STAFF RECOMMENDATION 211 Manchester Avenue December 21, 2016

Application: New construction—addition
District: Eastwood Neighborhood Conservation Zoning Overlay
Council District: 06
Map and Parcel Number: 08306012500
Applicant: Kaitlyn Smous, Nine12 Design
Project Lead: Melissa Baldock, melissa.baldock@nashville.gov

Description of Project: Application is to construct a rear addition. The addition will be seven inches (7") taller than the historic house.

1 SITE PLAN

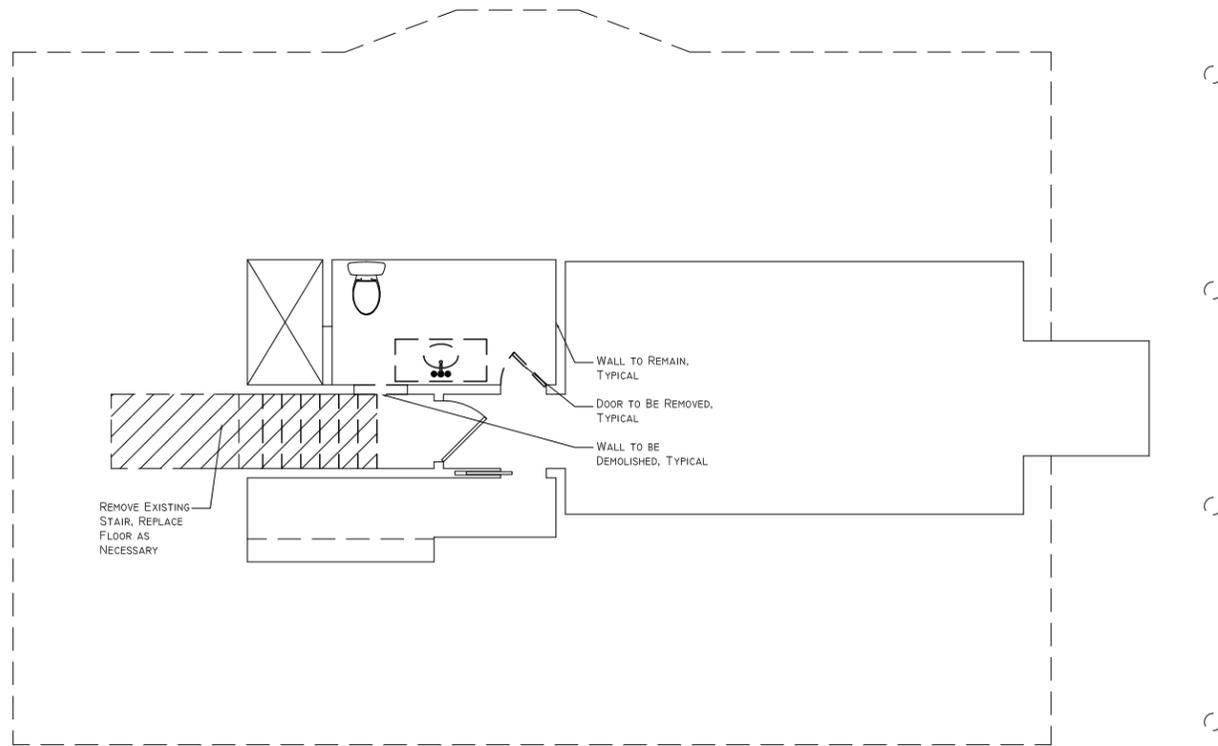
Setback & Rhythm of Spacing: The proposed addition meets all base zoning setbacks, and because the addition is no wider than the historic house, the house's rhythm of spacing on the street will not be affected. Staff finds that the setbacks and rhythm of spacing meet Sections II.B.1.c.and II.B.2. of the design guidelines.

Appurtenances & Utilities: No changes to the site’s appurtenances were indicated on the drawings. The location of the HVAC and other utilities were also not noted. Staff asks that the HVAC be located on the rear façade, or on a side façade beyond the midpoint of the house.

2. Staff approve the final details, dimensions and materials of windows and doors prior to purchase and installation; and,
3. The HVAC shall be located behind the house or on either side, beyond the midpoint of the house.

EXTERIOR
 ELEVATIONS

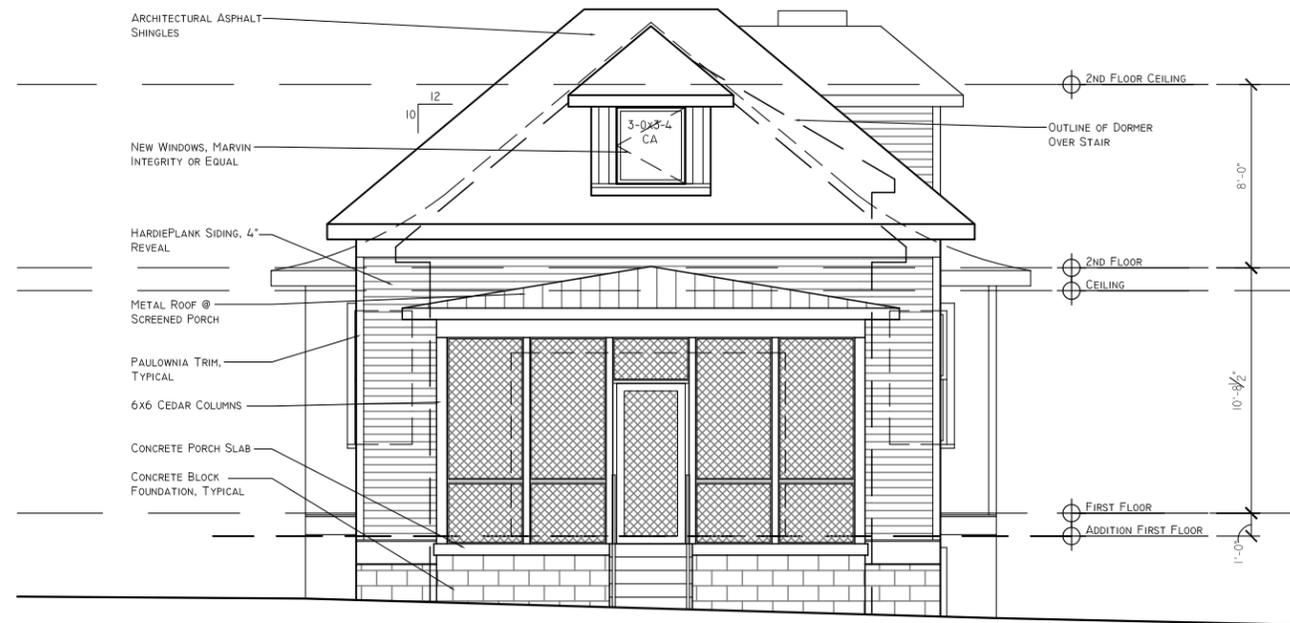
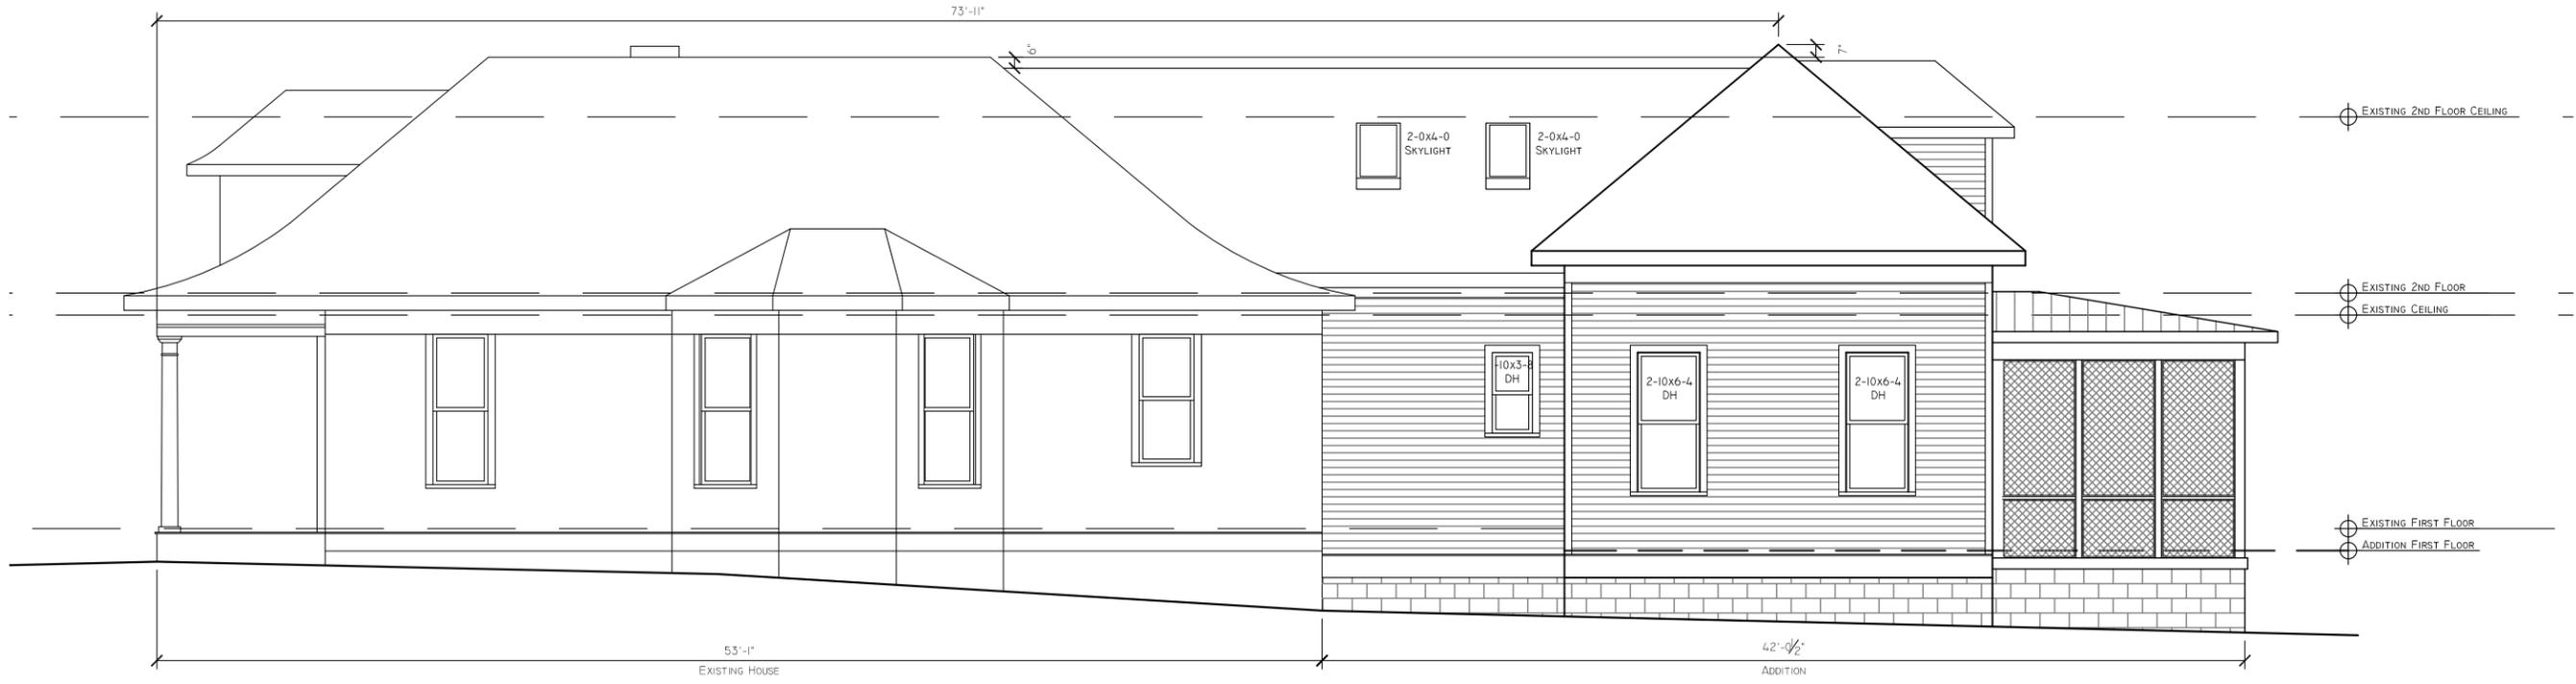
The addition will tie into the back corner of the house at a point approximately six inches (6") below the peak of the historic house's roof. At a point approximately twenty-one feet (21') behind the back wall of the house and seventy-three feet (73') from the front of the house, the addition rises in height to be seven inches (7") taller than the historic house. Staff finds this additional height to be appropriate because it is so far back and it is just seven inches (7") taller that it will not be perceived as much taller than the historic house from the street. In addition, the taller portion has a hipped roof form and is inset from the sidewalls of the historic house by at least two feet (2'), both of which will help to minimize its visibility.

The eave heights of the addition will be between one foot and two feet (1'-2') taller than the eaves on the historic house. Staff finds this to be appropriate because the addition is inset between two and five feet, five inches (2'-5'5") from the back of the house. The addition's foundation will be one foot (1') lower than the foundation line of the historic house. Again, staff finds this to be appropriate because the entire addition is inset from the sidewalls of the house and the foundation lines will be at most minimally visible from the street.

Proportion and Rhythm of Openings: No changes to the window and door openings on the existing house were indicated on the plans. The windows on the proposed addition are all generally twice as tall as they are wide, thereby meeting the historic proportions of openings. There are no large expanses of wall space without a window or door opening. Staff finds the addition’s proportion and rhythm of openings to meet Sections II.B.1.g. and II.B.2. of the design guidelines.

Staff finds that the height and scale meet of the addition meet Sections II.B.1.a.and b. and II.B.2. of the design guidelines.
